GROUP	MODEL
CHA	2019-2024MY Multiple Models
NUMBER	DATE
121 (Rev 1, 7/26/2024)	January 2024

TECHNICAL SERVICE BULLETIN

SUBJECT: **FRONT STRUT BEARING & SPRING PAD REPLACEMENT**

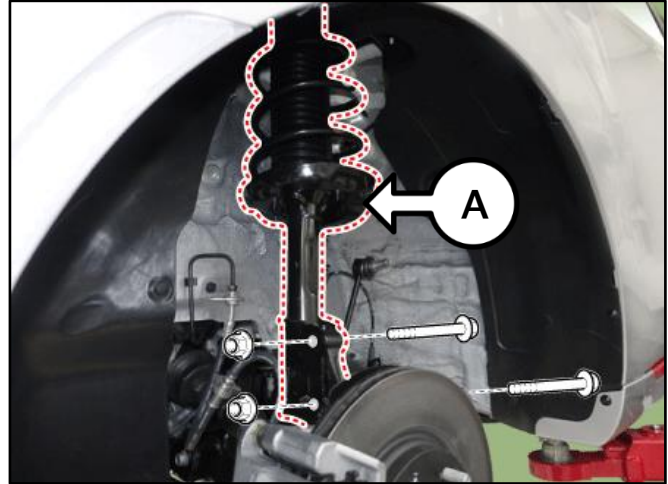
1. Remove the front strut assembly (A), both left and right side, by referring to "Suspension System → Front Suspension System → Front Strut Assembly/Front Strut Complete → Repair Procedures (Removal and Installation)" in the shop manual on KGIS.

2. Disassemble one of the front strut assemblies (A) by referring to "Suspension System → Front Suspension System → Front Strut Complete → Repair Procedures (Disassembly)" in the shop manual on KGIS.

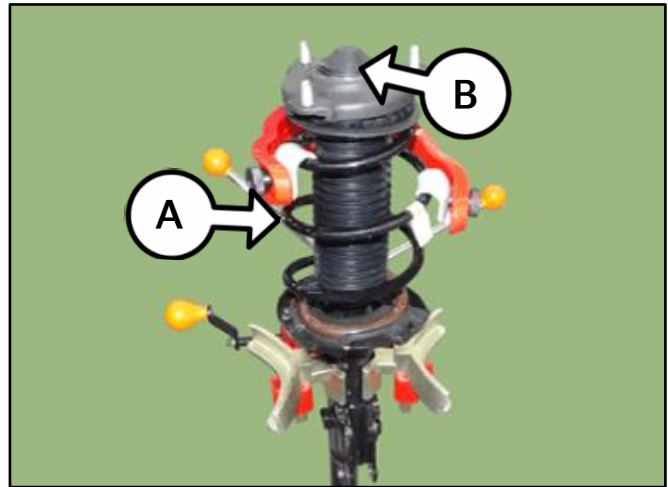
Note: SST 09546 3X100 is required to loosen the self locking nut (B). DO NOT reuse the removed locking nut (discard after removal).

3. Replace the strut bearing (C) and the spring pad (D) with the new parts.

Note: INSTALL a 'new' locking nut (B).

Tightening torque for locking nut (B):
39.8 - 54.2 lb.ft (53.9 - 73.5 N.m)
